NUMBER	16TSB-85			TYPE	SERVICE ALERT		
ROUTING	INSTALL	X	SERVICE	X	SALES	PURCH	
TITLE	G2 HPU MOTOR DRAINAGE - DRAIN PLUG ORIENTATION						
REV	A			ISSUED	12/7/2018	REVISED	-
AFFECTS	ALL SNOWDOGG G2 PLOWS - HD2/EX2/VXF2/TE2						
INFORMATION	<p>The motor used on the SnowDogg HPU's has small plastic drain plugs that should be removed to allow drainage of any condensation or water that has entered from normal use. These drain plugs were oriented incorrectly at assembly. This can be corrected by removing the motor cap, removing the plug, and reinstalling the cap at 180 degree rotation from it's original location OR by adding a drain hole (if easier).</p> <p>If a plow is exhibiting "weak" behavior - it's possible that moisture is trapped in the housing causing corrosion/friction. Please correct the drain plug as shown below on any plows brought in for service. The motor service P/N is 16151200</p> <p>This should be also be checked on ALL NEW G2 SnowDogg plows at time of installation to prevent future service issues.</p>

CORRECTION

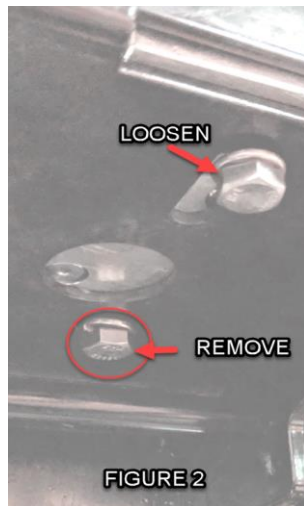
1. Inspect the motor for cap orientation and plug removal as shown in FIGURE 1. If the cap and plug are correct - no further action is needed. This TSB is to address HPU's with the plugs as shown in FIGURE 3.

5. Remove the screws and motor cap
6. Remove the plastic drain plug shown in FIGURE 4
7. Reinstall the cap with the open drain holes in the DOWN position as shown in FIGURE 1
8. Reposition the HPU and reinstall the 3/8-16 screws and access panels.
